SHIELDALLOY METALLURGICAL CORPORATION

January 28, 1994

RE: Request for Additional Information for Environmental Assessment
(TAC No. L21474)

ATTACHMENT 3

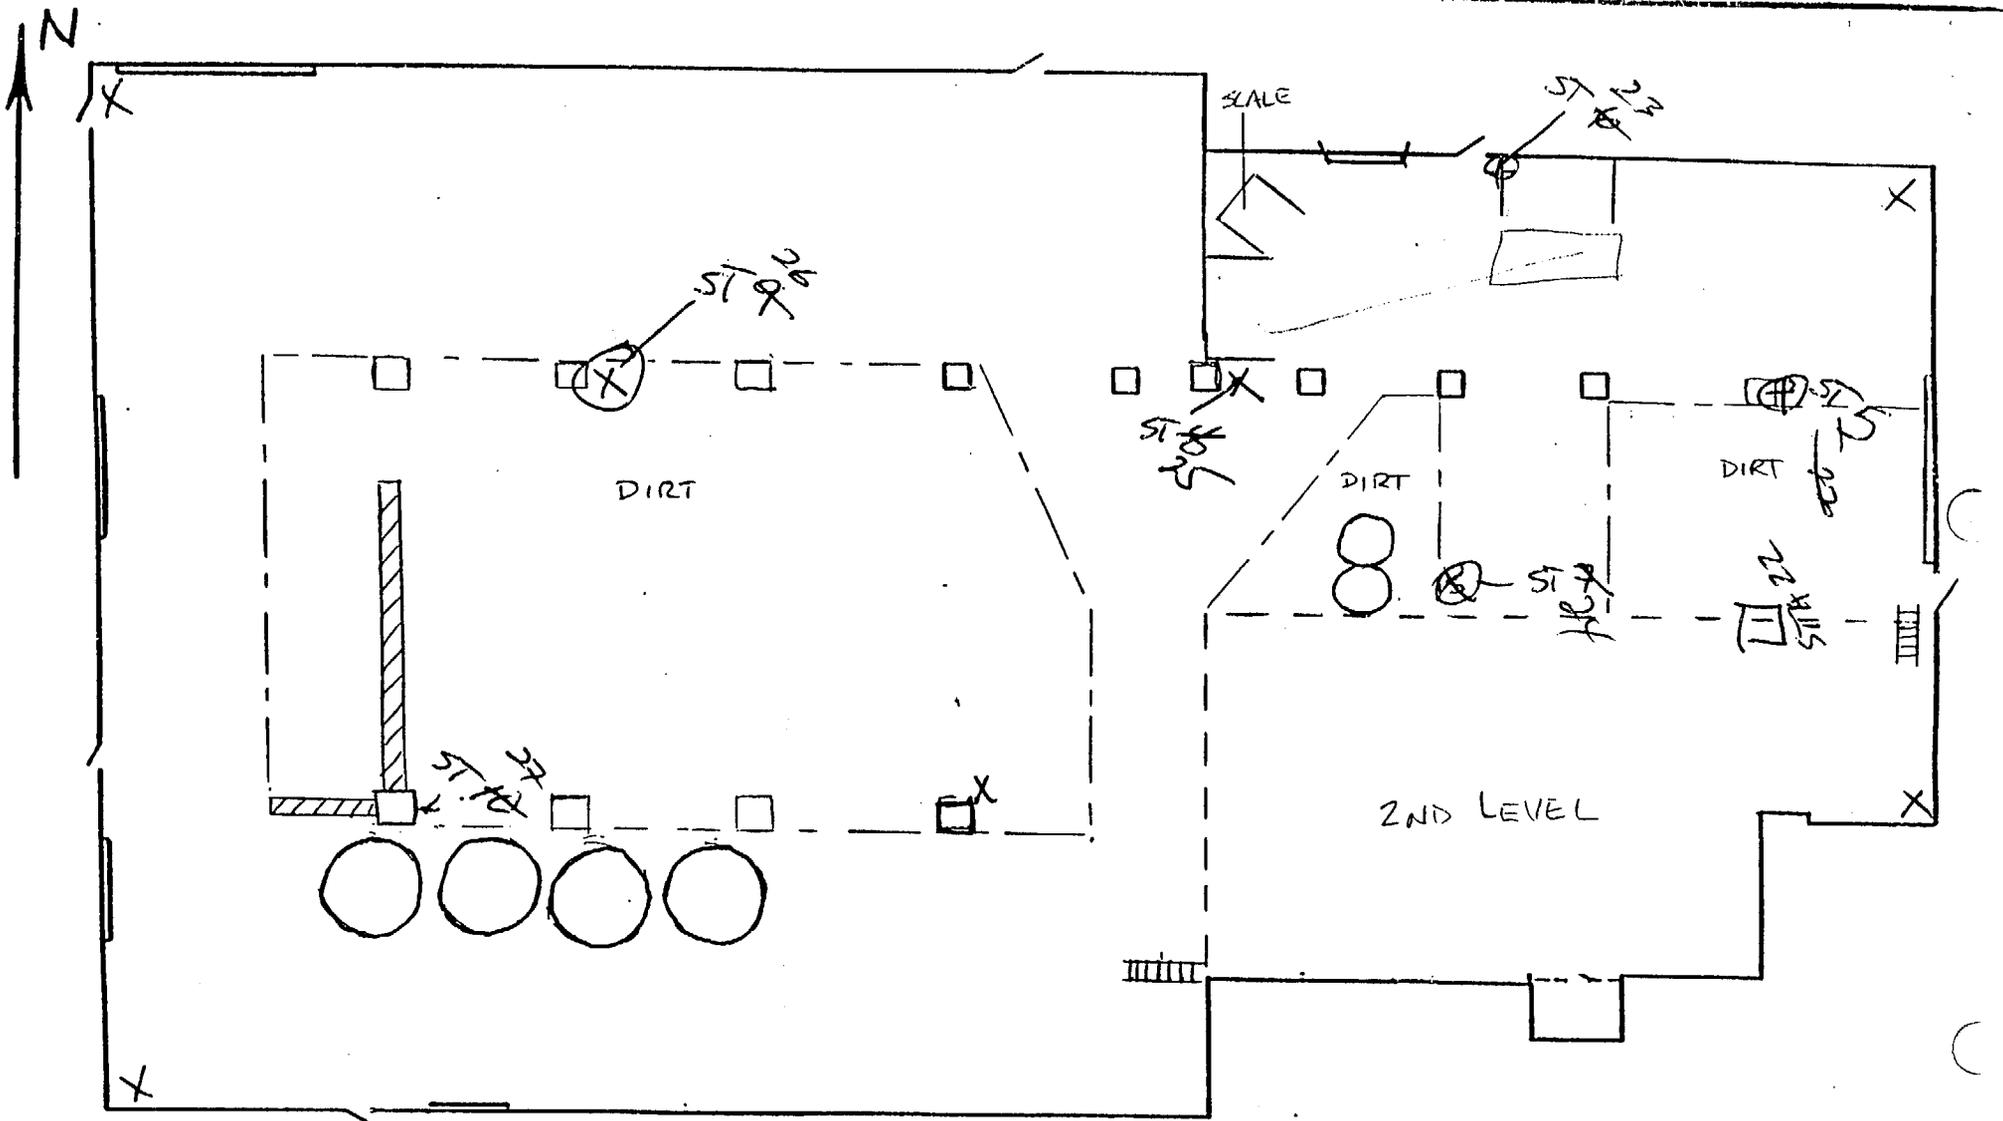
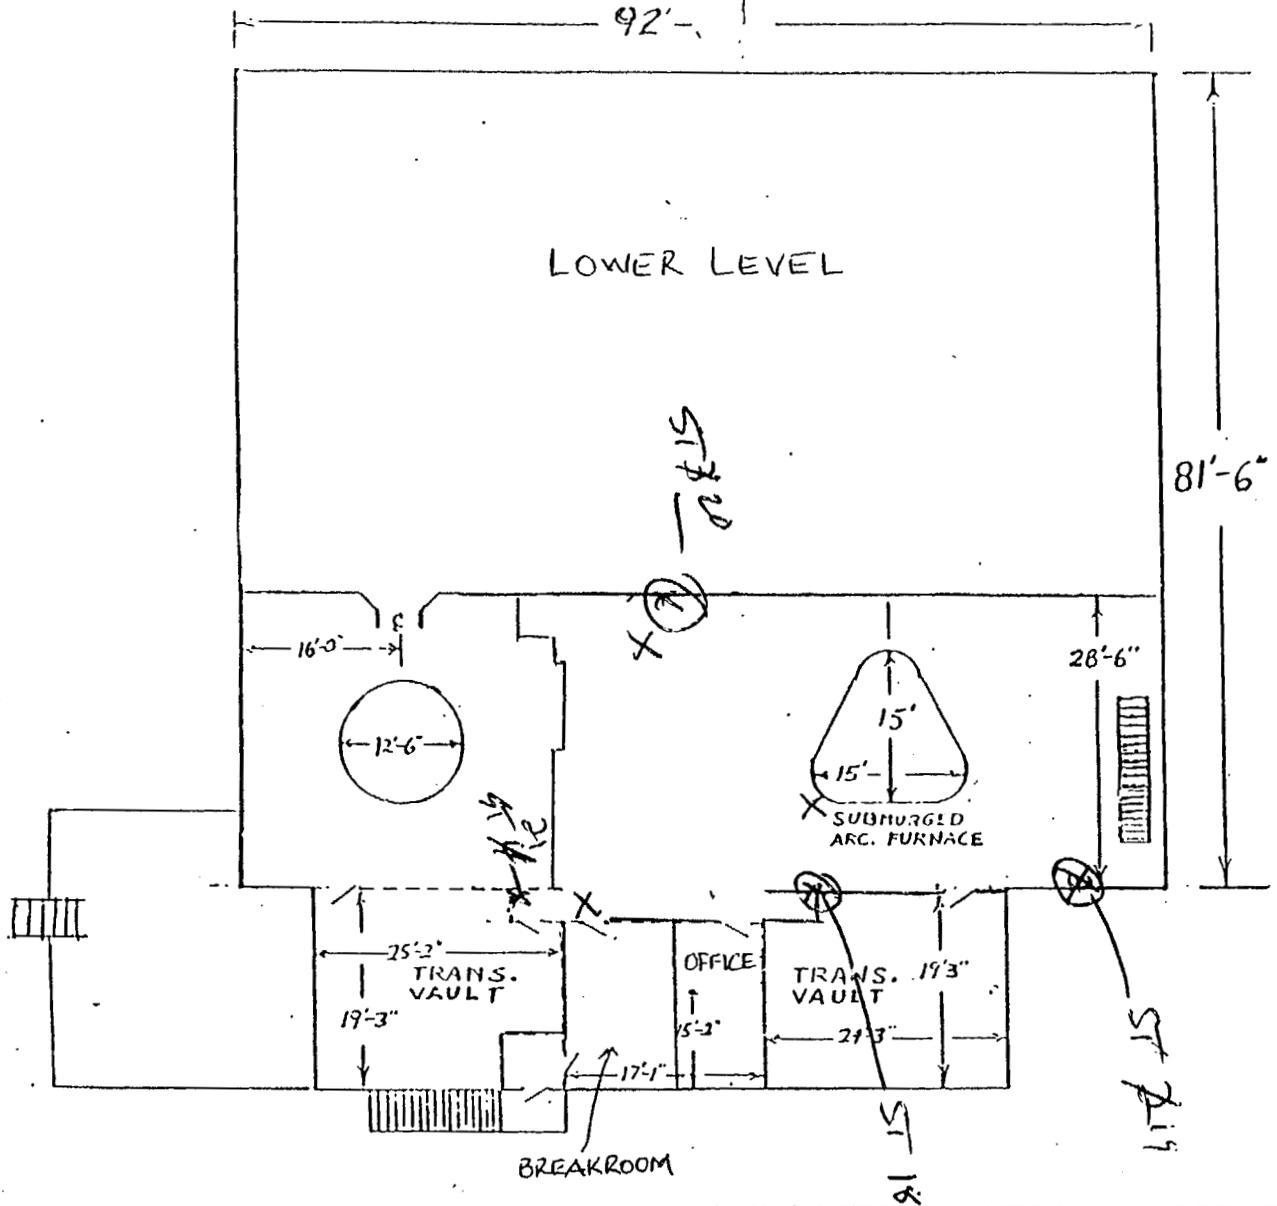
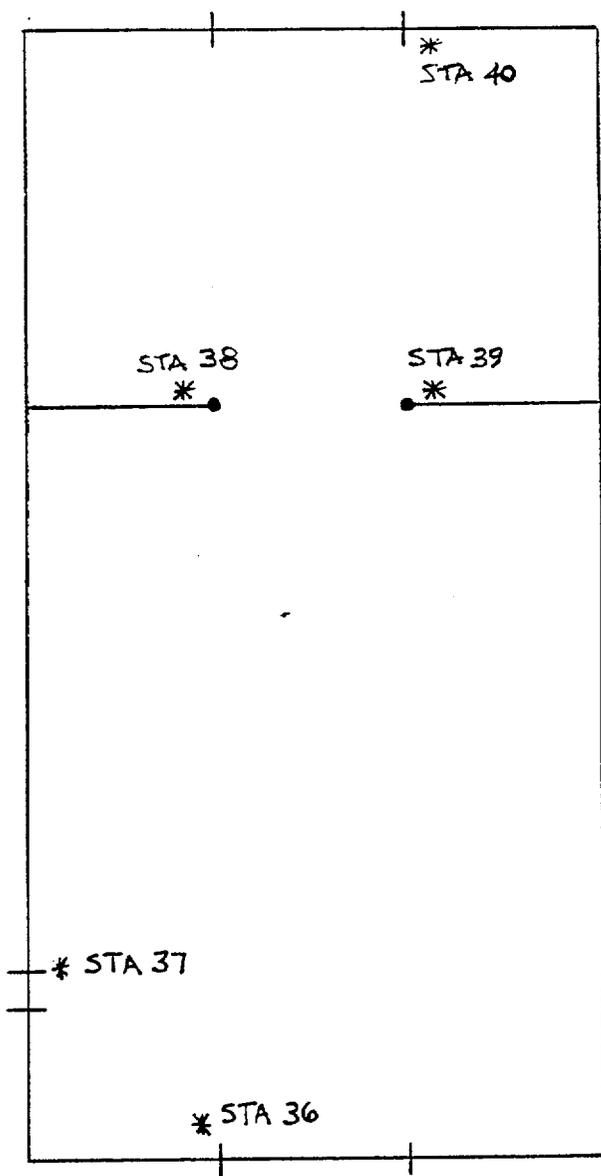
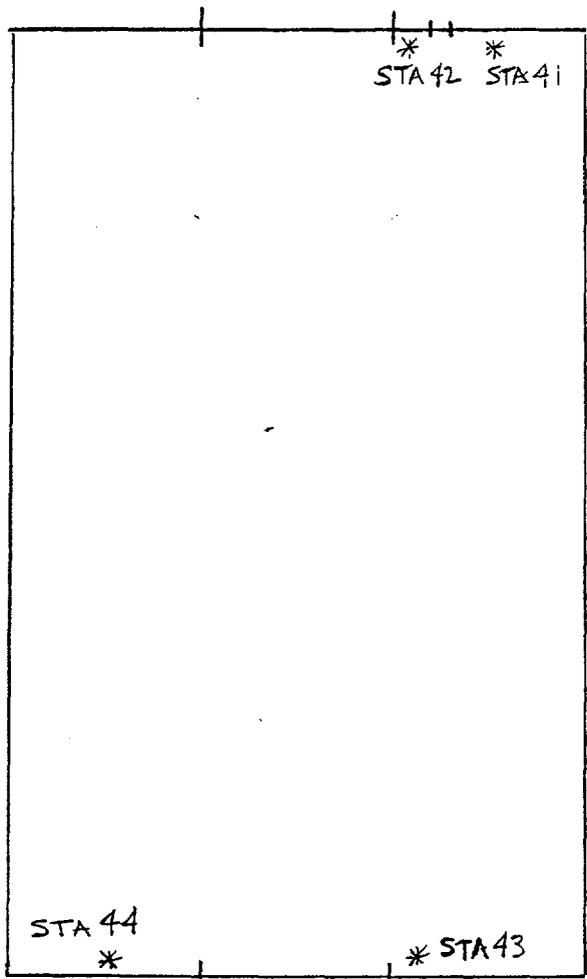
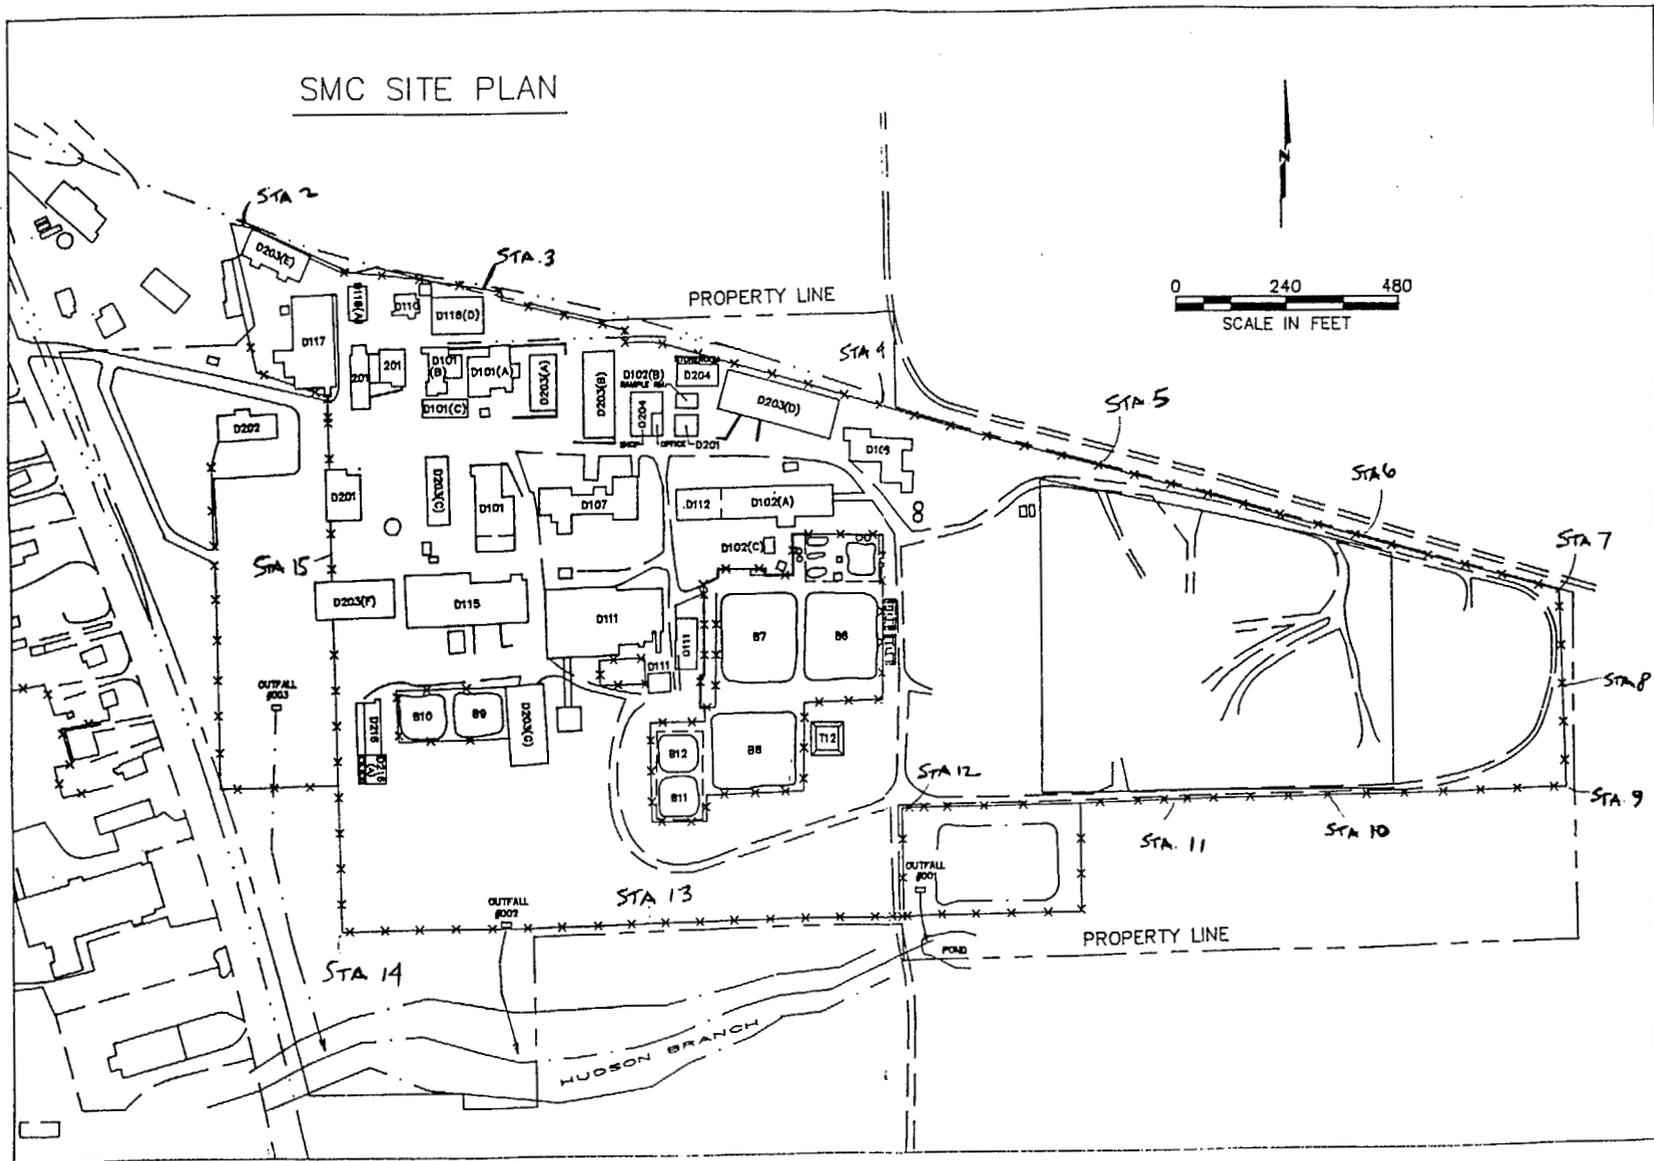
4. Indicate how many "Area-TLDs" are found in and around the facility and show their locations.

There are approximately 44 "Area-TLD" locations in and around the facility. This TLD information was provided to Mr. Ikenberry (PNL) on 8/24/93 via facsimile. This information is provided (Attachment 3) for expedience.
